**Title:** Text proposal for 25.211

This text proposal includes updated figures for TX diversity and for shared channels. The text and figure of Appendix A is also updated.

Fig. A-1 Transmitter power control Timing

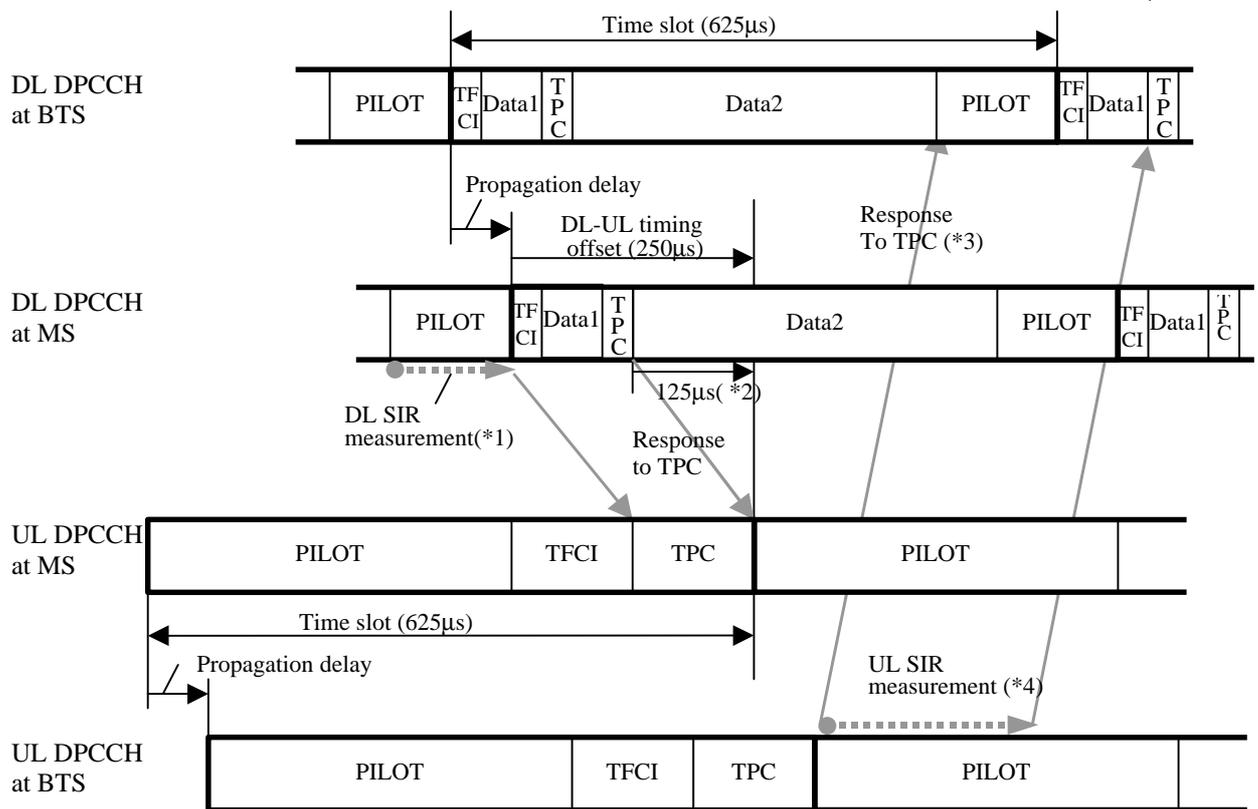
<Editors note: The Power control timing described in this appendix should be seen as an example on how the control bits have to be placed in order to permit a short TPC delay. It seems appropriate to move this part later.>

In order to maximize the BTS-UE distance within which one-slot control delay is achieved, the frame timing of a reverse-uplink DPCH is delayed by 250µs from that of the corresponding forward-downlink DPCH measured at the MS-UE antenna. Responding to a forward-downlink TPC command, MS-UE shall change its reverse-uplink DPCH output power at the beginning of the first reverse-uplink pilot field after the TPC command reception. Responding to a reverse-uplink TPC command, BTS shall change its DPCH output power at the beginning of the first of later forward-downlink pilot field after the TPC command reception. Note that the delay from the reverse-uplink TPC command reception to the power change timing is not specified for BTS. MS-UE shall decide and send TPC commands on the reverse-uplink based on the forward-downlink SIR measurement. The TPC command field on the reverse-uplink starts, when measured at the MS-UE antenna, 125µs after the end of forward-downlink pilot field. BTS shall decide and send TPC commands based on the reverse-uplink SIR measurement. However, the SIR measurement periods are not specified either for MS-UE or BTS.
